**DHSS HOLLOWAY CHAPEL ADMINISTRATION BUILDING
HOUSEKEEPING RENOVATIONS
HOLLOWAY CAMPUS, NEW CASTLE, DELAWARE
DBF #586B035.J01 □ OMB/DFM# MC350100025
JULY 23, 2015**

ADDENDUM NO. 2

ADDENDUM NO. 1

Dwg.No.:
SKP-1

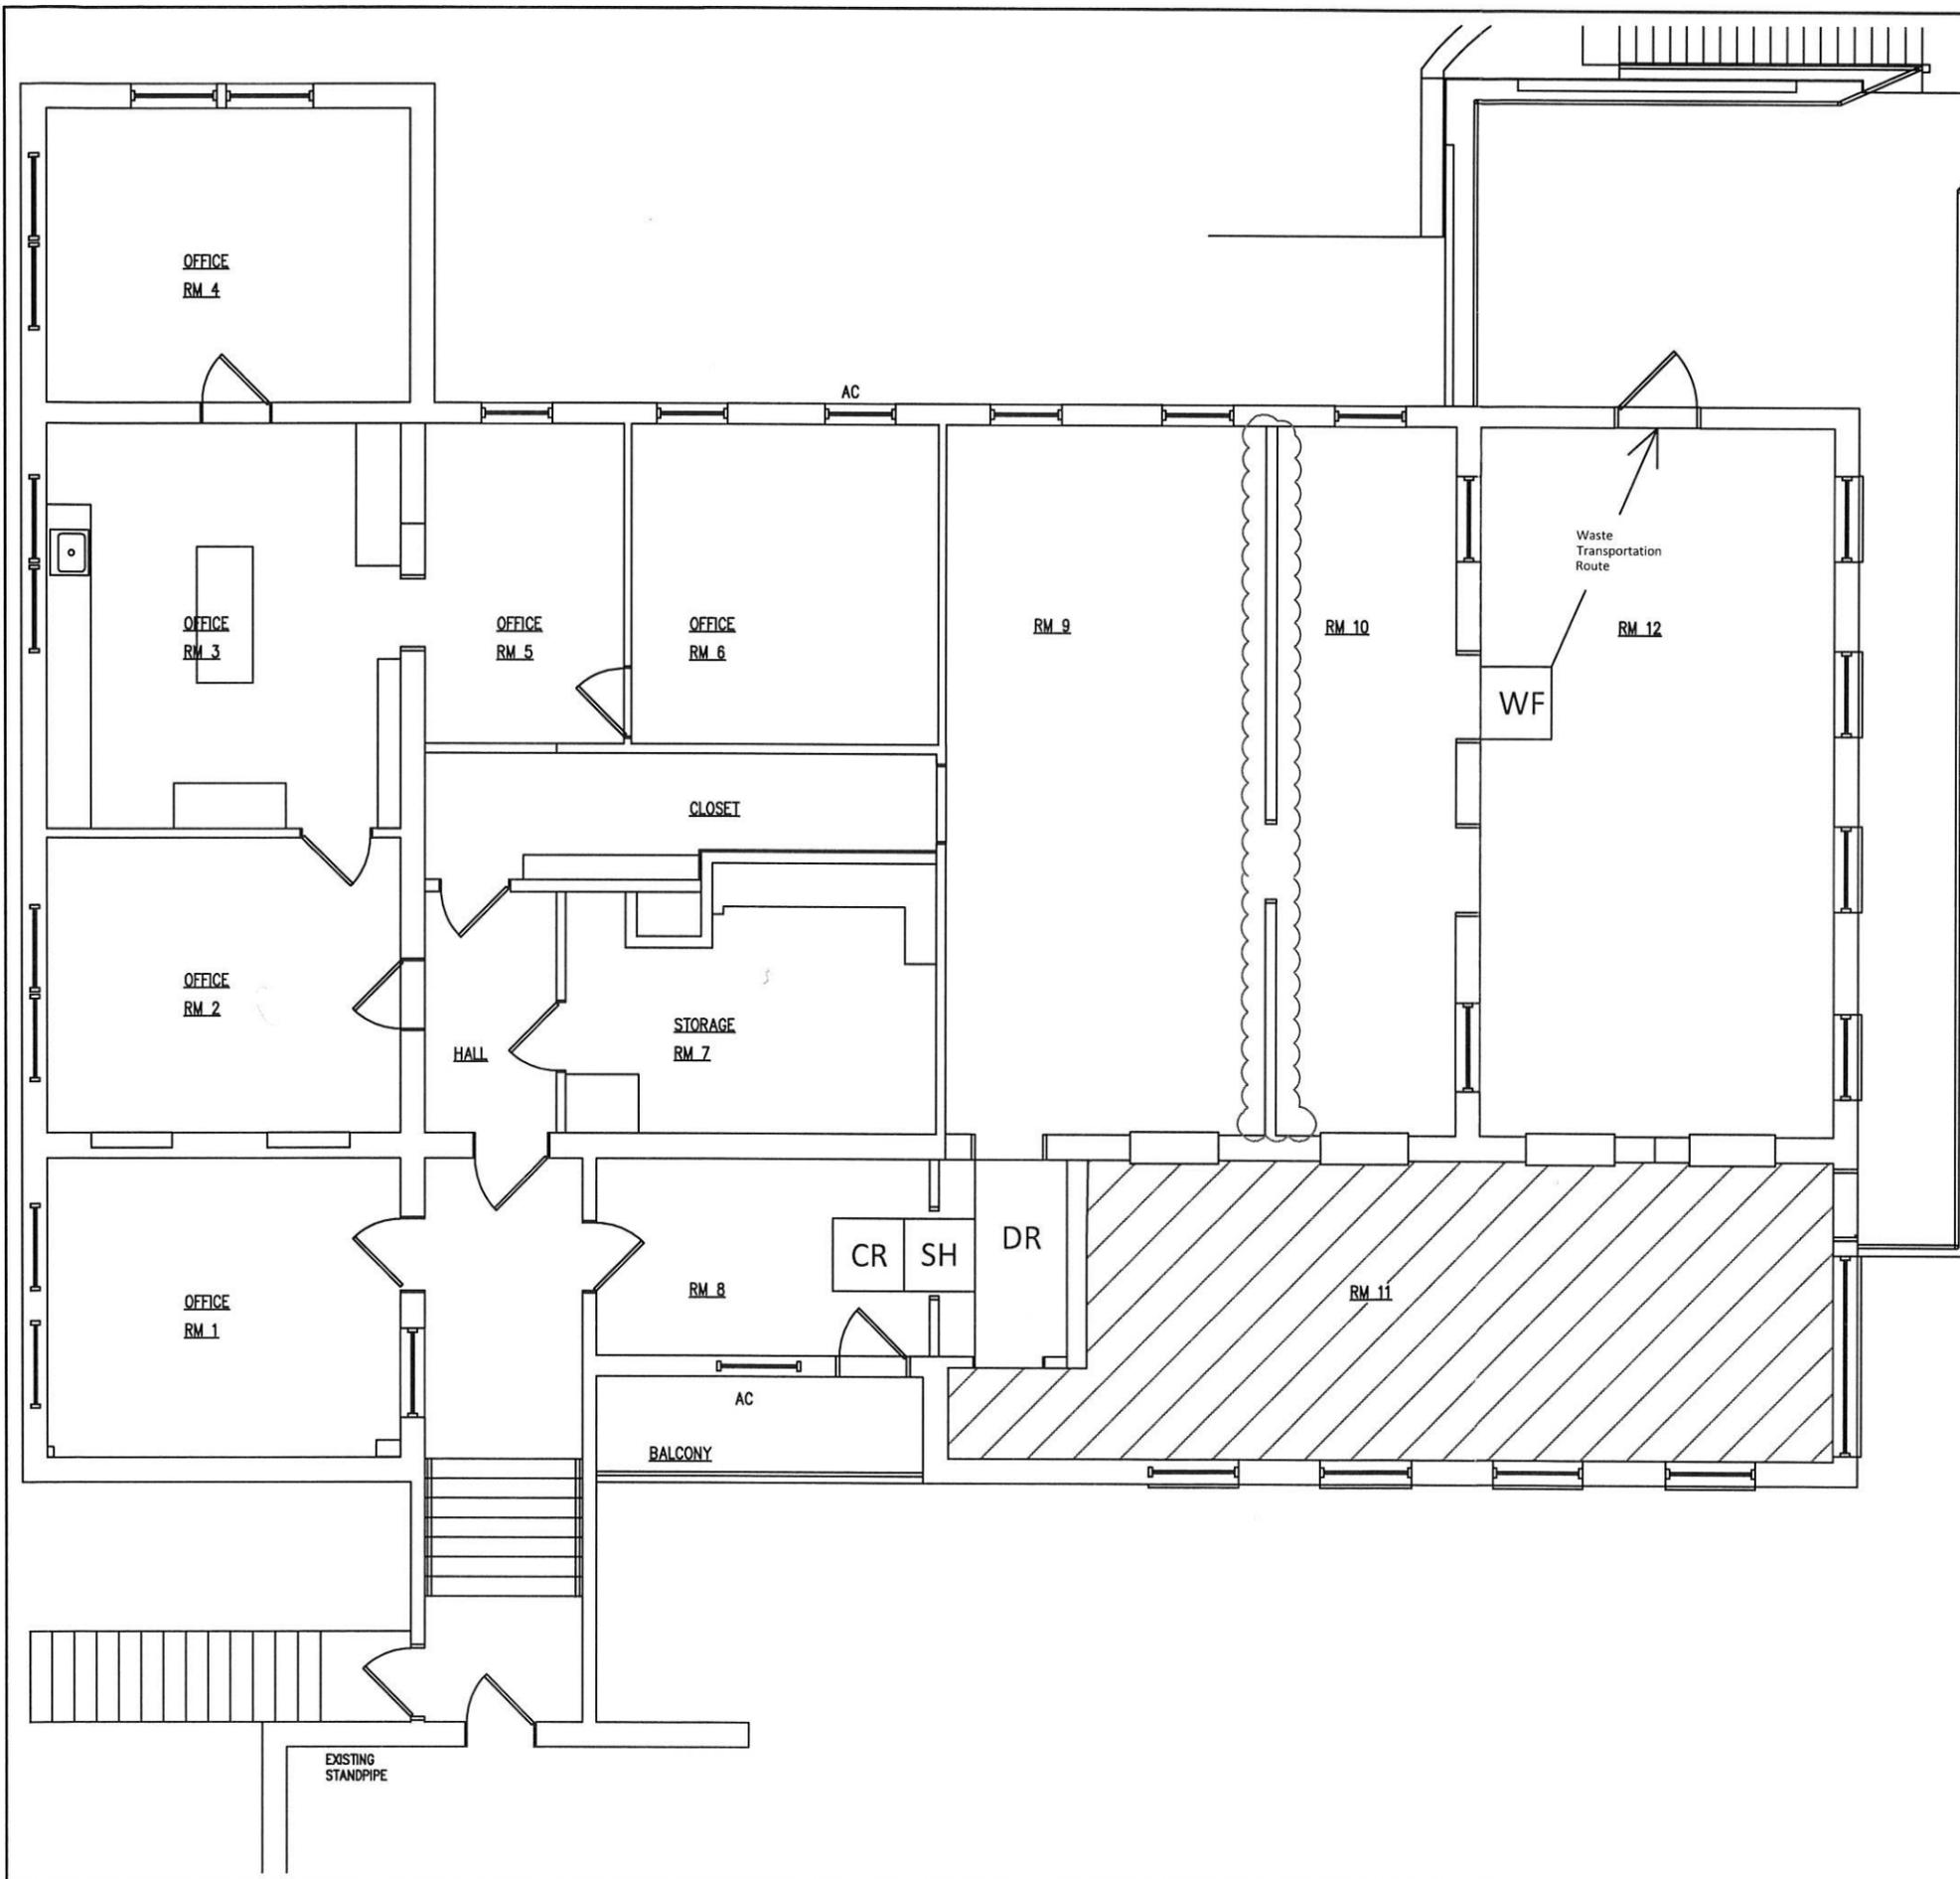
- Item No. 6 Refer to Drawing Sheet P2
- ADD Sketch SKP-1. Refer to the attached Sketch SKP-1 for installation of the new vent piping penetration through the existing shingle roof.
